**RE: Request to review RFS Bush Fire Safety Authority – Peninsula Gardens**

The purpose of this letter is to request a review of the NSW Rural Fire Service (RFS) Bush Fire Safety Authority dated 23<sup>rd</sup> October 2018 (RFS Ref: D18/926) regarding the application for an addition to the Peninsula Gardens retirement village at 79 Cabbage Tree Road, Bayview.

**Figure 1: Revised Asset Protection Zone (APZ)**

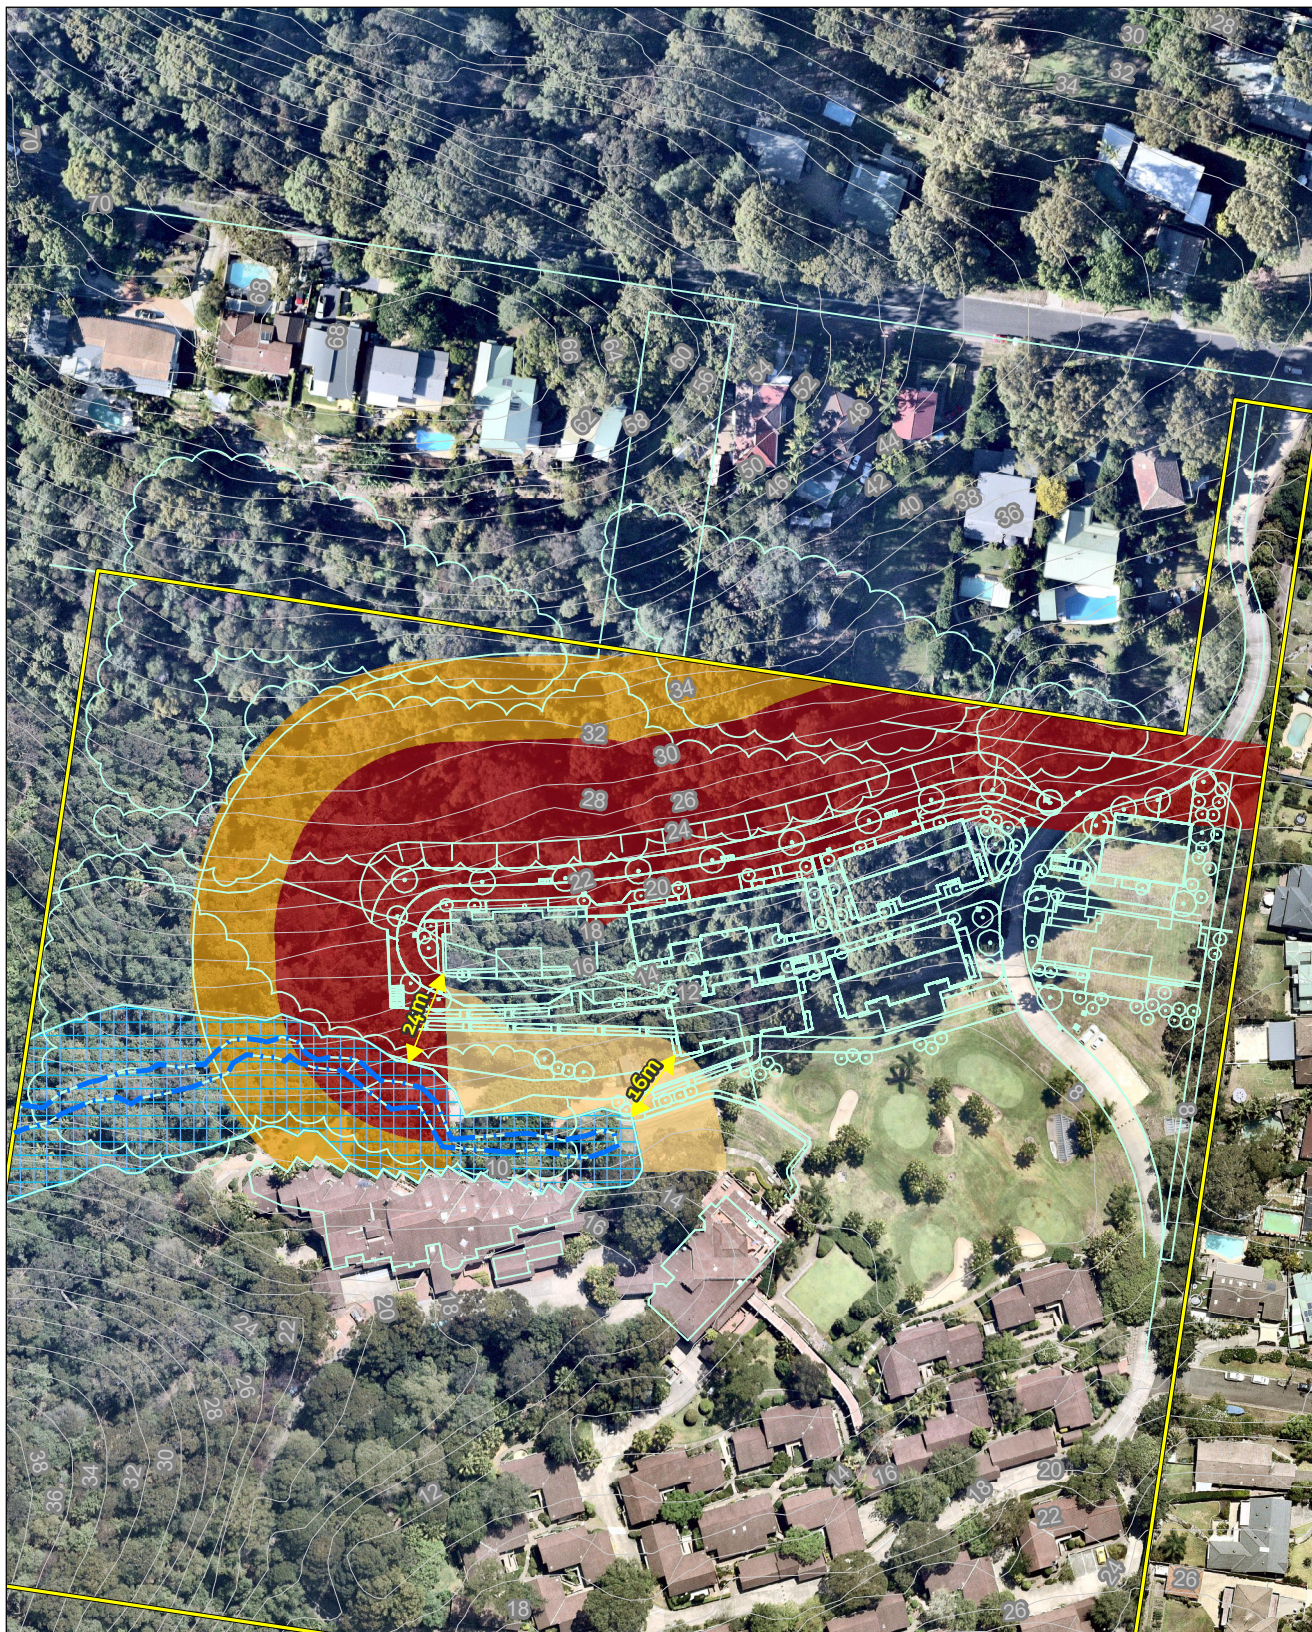
The development proposal has since been altered by deleting units at the western end of the development increasing the separation to the riparian zone. The proposed approach to providing bushfire protection from the riparian zone remains to be one of defensible space rather than a specific APZ distance stipulated by PBP Table A2.6 for the following reasons:

1. The riparian zone is only 20 m wide and sits within the 60 m APZ between the proposed buildings on the northern side of the drainage line and the existing buildings on the southern side of the drainage line. The riparian corridor will sit amongst a managed environment.

2. The fuel load within the riparian zone consists of Coachwood Warm Temperate Rainforest only, which extends to the west beyond the 60 m APZ.
3. The 'Acceptable Solutions' for determining APZ distance listed in Table A2.6 of PBP do not cater for such narrow and low risk hazards as described in Points 1 and 2 above. The vegetation classification of 'low hazard' is overly conservative for the risk attributes of the corridor and therefore not an accurate classification.

4. The proposed defensible space will be managed to an Inner Protection Area (IPA) standard (within the 60 m APZ) and will include access roads. At its narrowest point, the defensible space will be 20 m between the riparian corridor and ILU 15/16 and 24 m to ILU 8. ILU 15 at 16 m separation will be amended to ensure a minimum 20 m defensible space.

The location of the riparian corridor and proposed APZ/defensible space is shown on the attached.

It is requested that RFS review Point 1 of the Bush Fire Safety Authority to remove the requirement for the 30 m APZ to the riparian corridor and replace it with the requirement for a minimum 20 m defensible space.
